Memorandum

To: Planning Commission
From: Niall Connolly, Director of Community Development
Date: September 11th, 2026
Re: Design Development Review for Parking Lot Expansion at 50 Zion Park Blvd

Figure 1. Pipe which is proposed to be upsized to deal with additional runoff

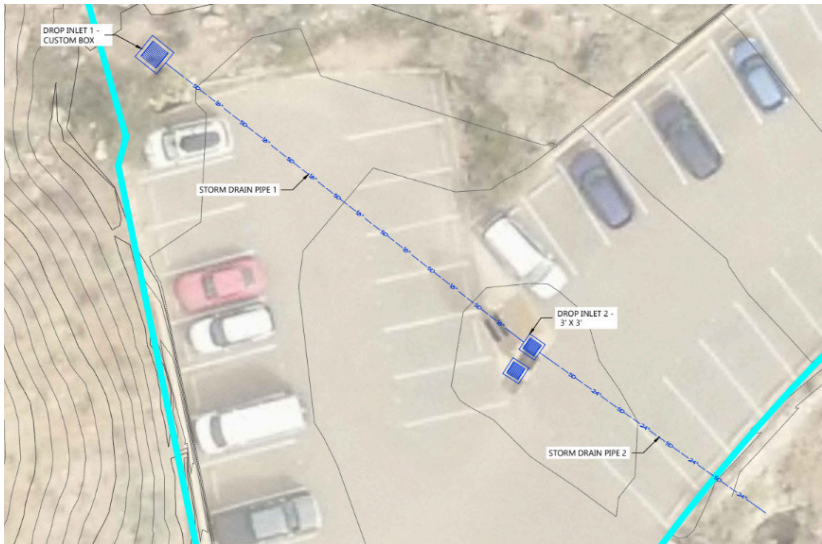
Mr. Wilson provided some information relating to storm drainage, which is appended to this staff report. In summary, there is an existing storm drain which traverses the site. The Engineers have proposed to upsize this drain to provide the additional capacity and detention volumes. This has been reviewed by the Town Engineer. The Town Engineer has confirmed that this would be an acceptable solution and would mitigate the extra surface water runoff arising from new asphalt.

1. Any outdoor lighting on the retail/ rental kiosk must be compliant with the Town's outdoor lighting ordinance. The applicant shall provide relevant details to Town staff for approval.
2. The proposed surface water drainage improvements must be completed to the Town Engineer's specifications, prior to the new parking spaces being used.
3. Trash and recycling receptacles must be provided in the parking lot, as required by the Town Code.
4. The mobile business shown on the site plan is not part of the approved site plan.

PROPOSED RENDERINGS – AUTOMATED RETAIL & RENTAL KIOSK

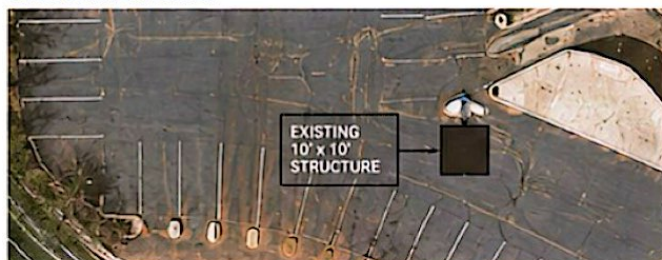
No outdoor lighting is proposed, however the rendered images of the retail/ rental kiosk show some lighting. It would be appropriate for the Commission to clarify this question by using a planning condition.
